RE: 1900 East Avenue, Montara, CA

ARBORIST REPORT and TREE PROTECTION PLAN

From: Daniel Krug
Sent: Thursday, January 3, 2019 11:34 AM
To: Camille Leung
Subject: Re: 1900 East PLN2014-00490

Site Plan with Additions

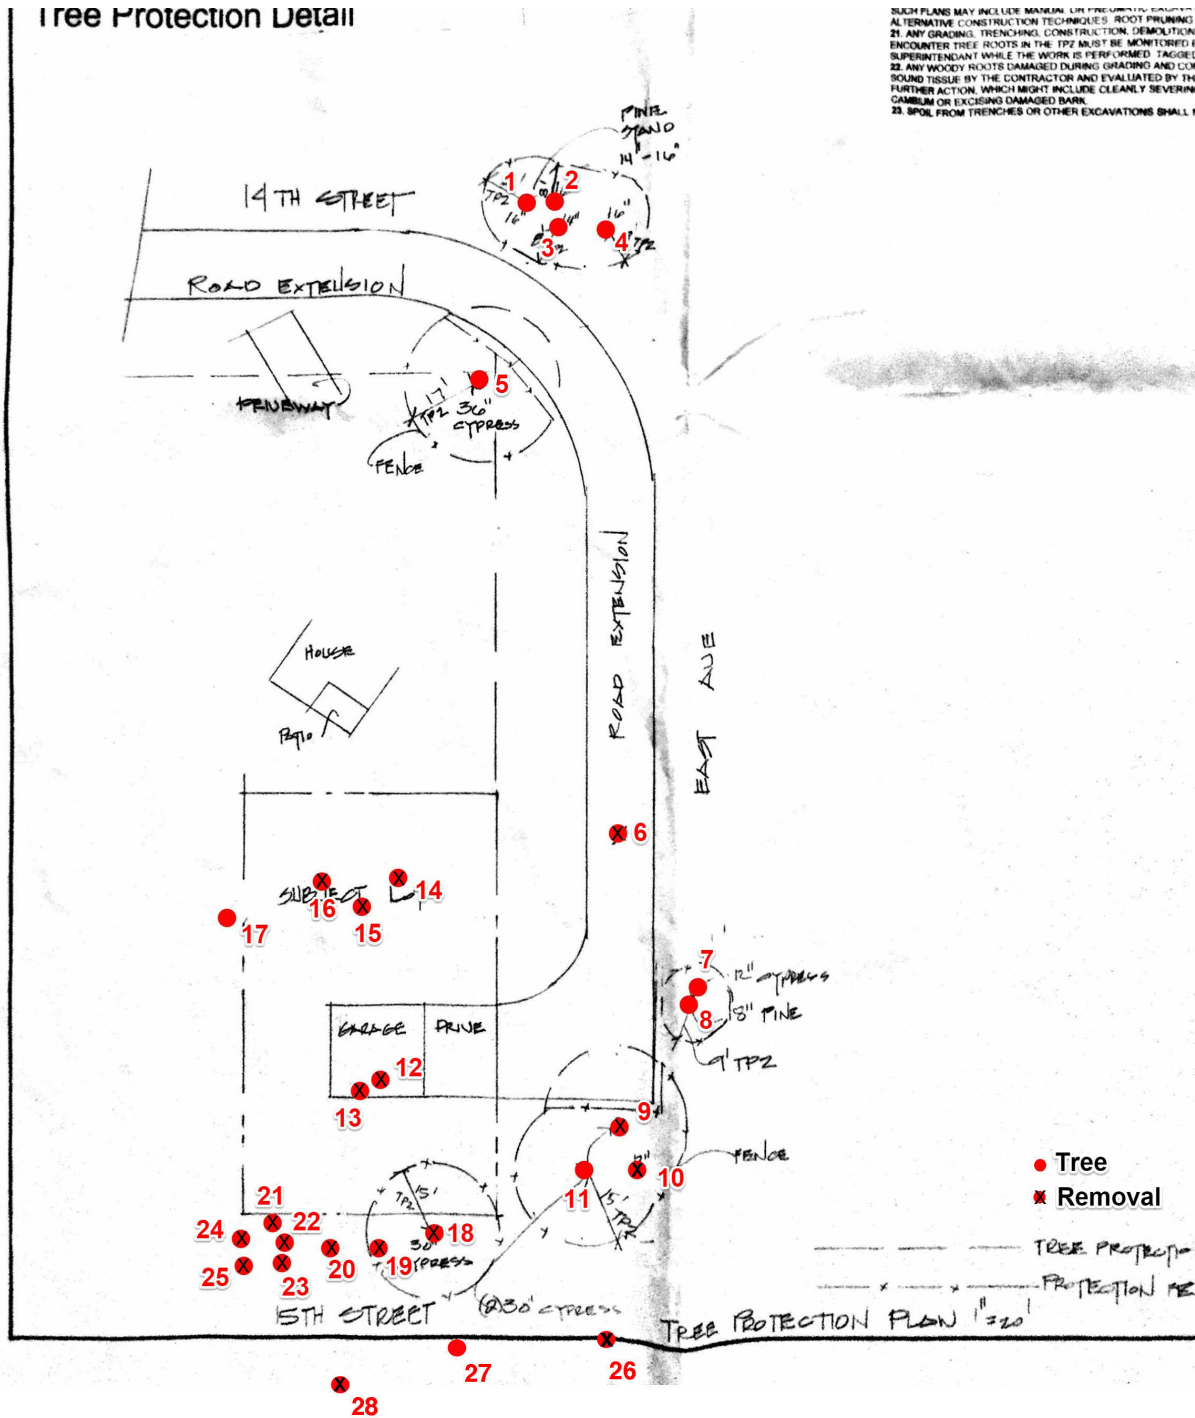
1. Roy - Tree #10 is not marked for removal on the map but is shown in the table as to be removed. Please clarify.
2. Roy and Sigma - The MidCoast Community Council has suggested that the curve of the driveway at 14th/East Avenue be widened to avoid intruding in the drip line canopy of the large 40" Cypress tree (shown as 36" in civil plans). Smaller trees are located to the north of driveway perhaps can accommodate greater canopy intrusion in order to save/better protect this tree?
3. Roy - Please clarify the diameter of Tree #9 as shown in the table.
4. Sigma – For purposes of the Neg Dec, can you synch the tree dimensions provided on your plans with those Roy has provided. This would avoid a lot of confusion.

1. Item #3 from 4/2/18 comments (see below) has not been addressed.
2. On table, show Tree #26 as to be removed.
3. On map, show Tree #28 with an "x", as it is shown as to be removed on the table.

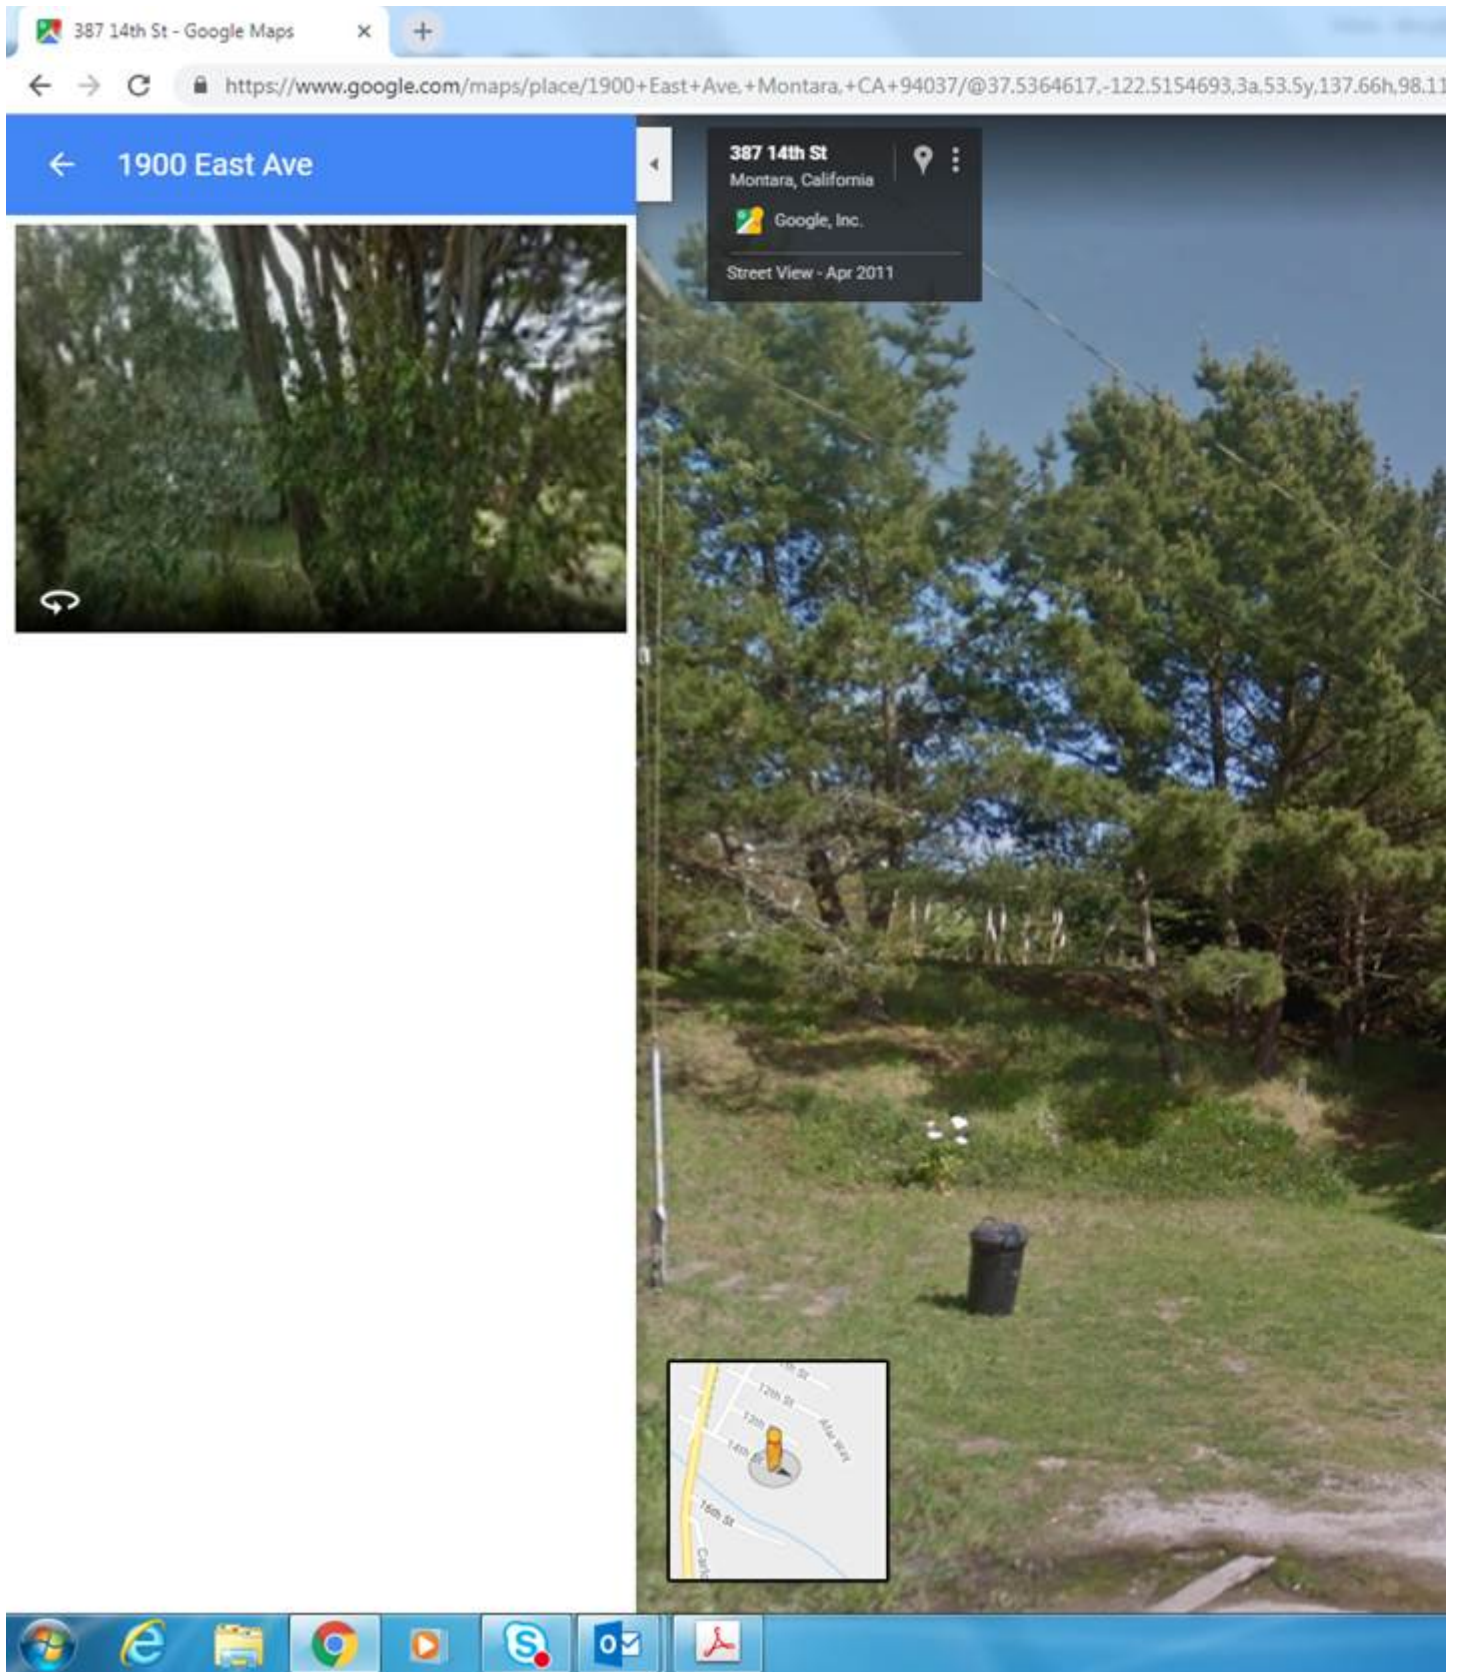
Please find our civil comments for just the road portion of this project.

Revise and resubmit.
